REFLECTION RIDGE 6TH ADDITION TO WICHITA, SEDGWICK COUNTY, KANSAS

FINAL PLAT

Re: S/D 91-6 - Reflection Ridge 6th Addition

CASE NUMBER: S/D 91-6 - REFLECTION RIDGE 6TH ADDITION

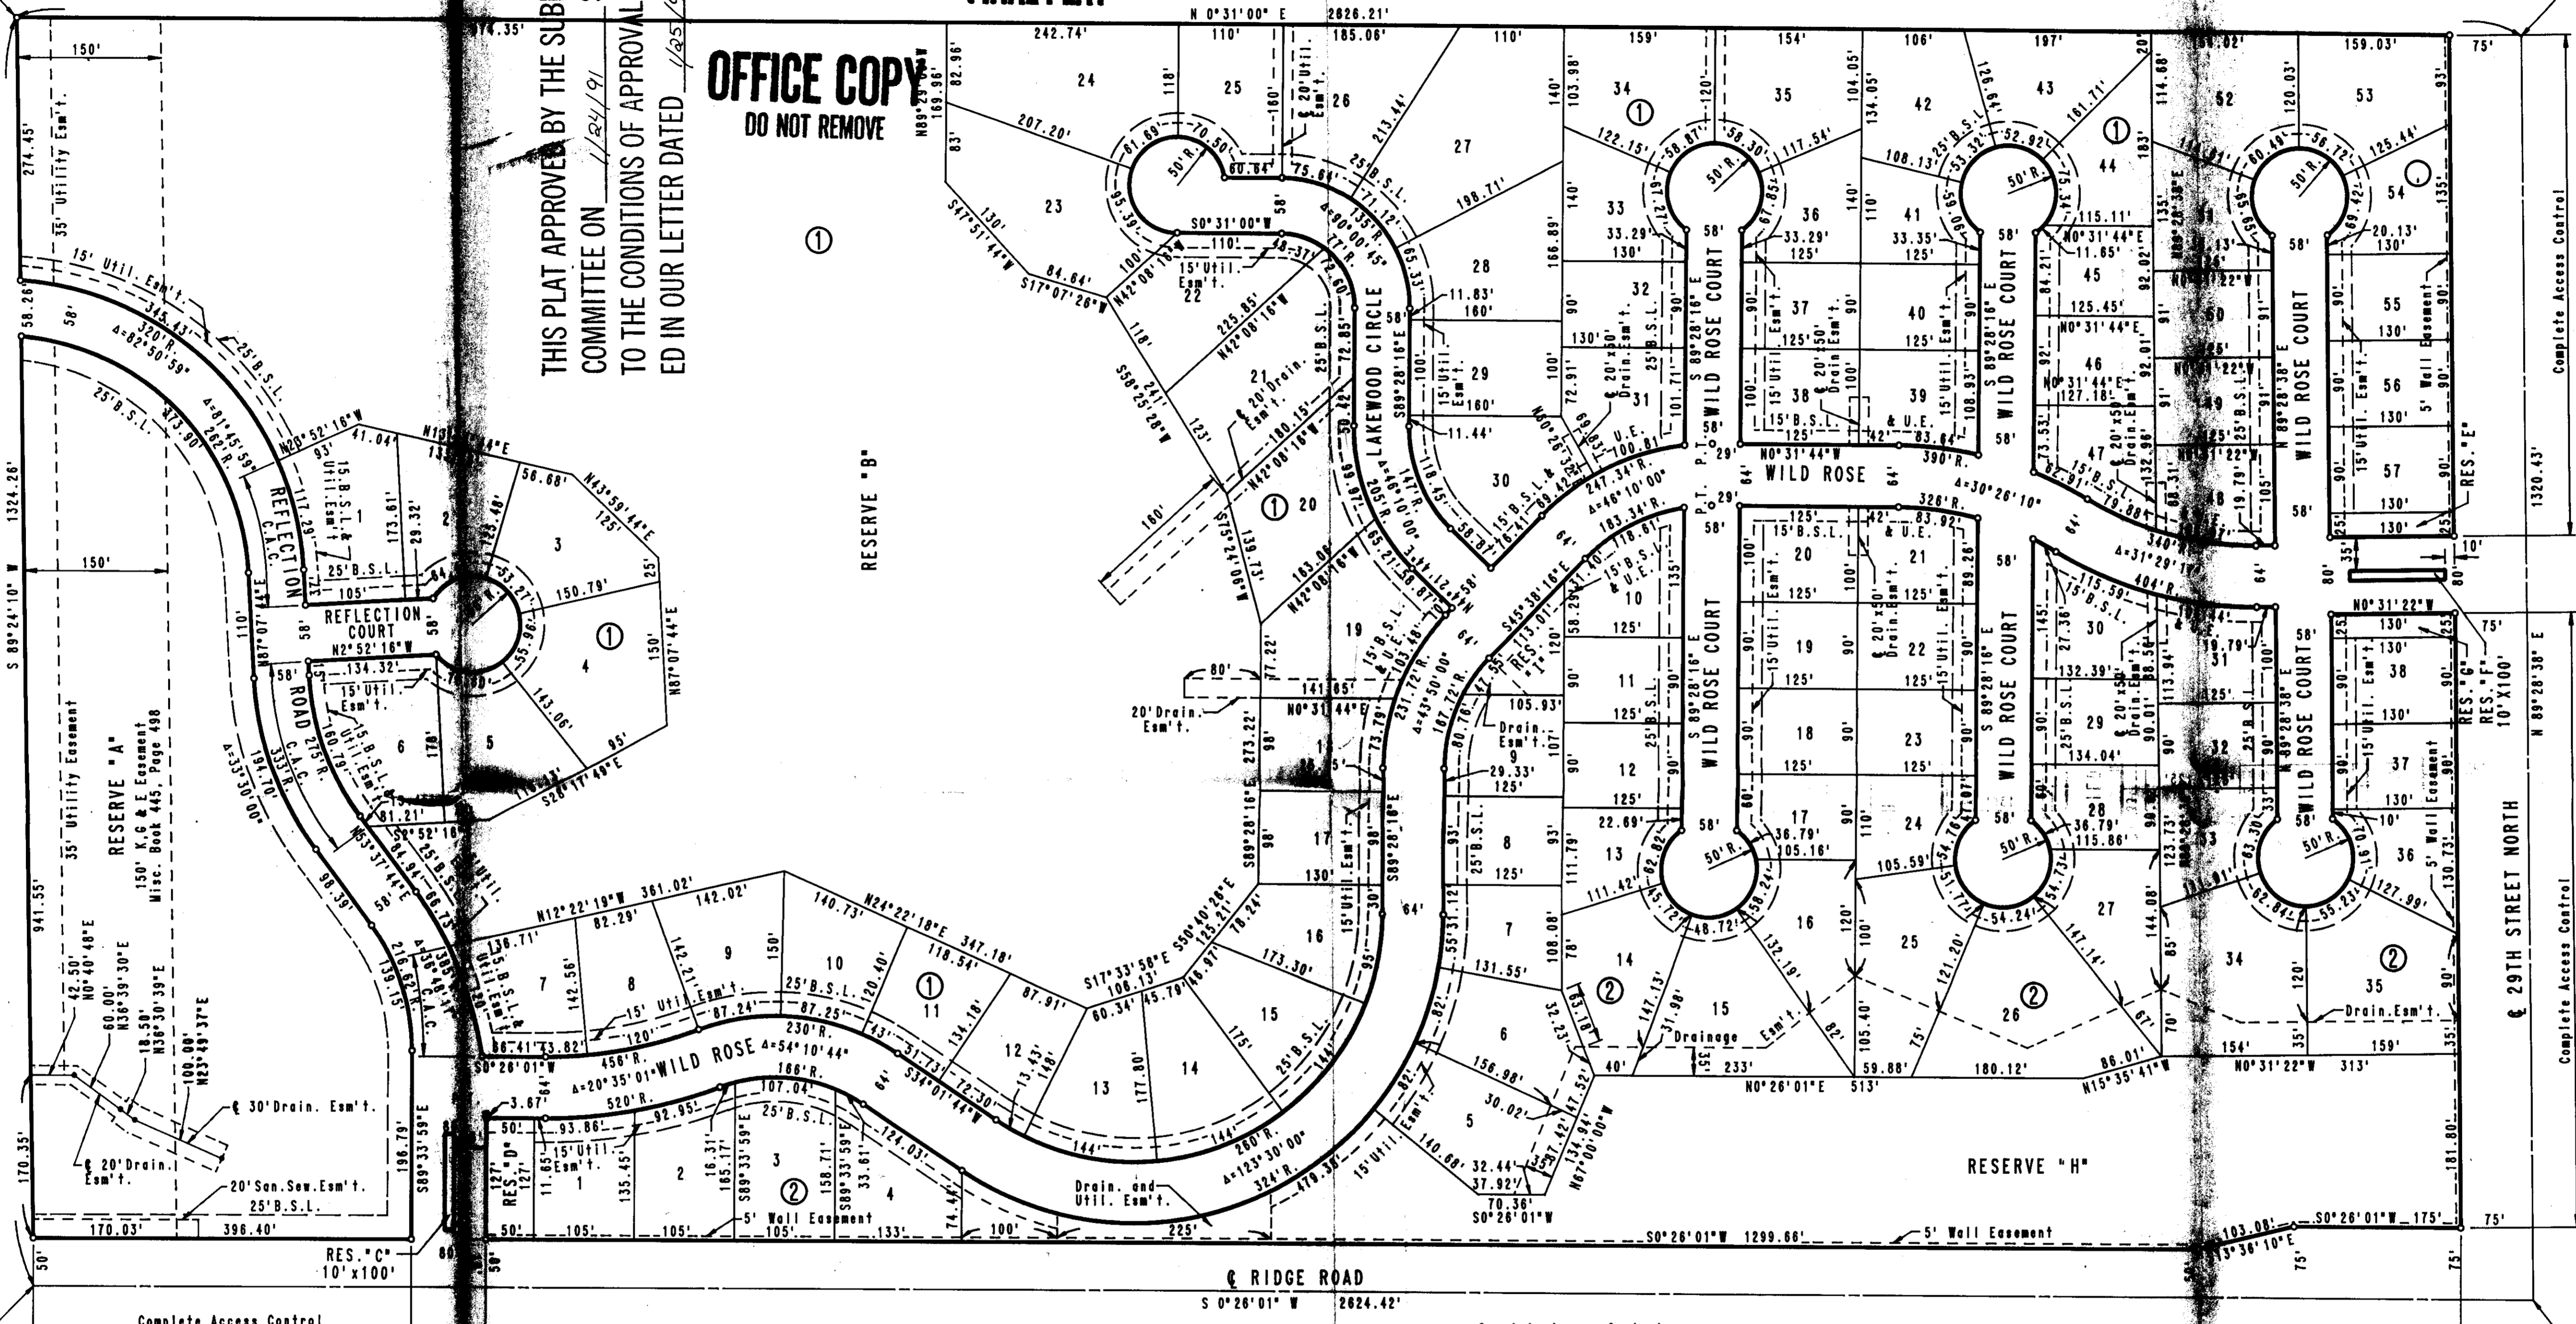
- J. On the final plat tracing, the references to the minimum pad elevations shall be amended to note that these elevations refer to the "(lowest opening)" rather than "(minimum opening)."
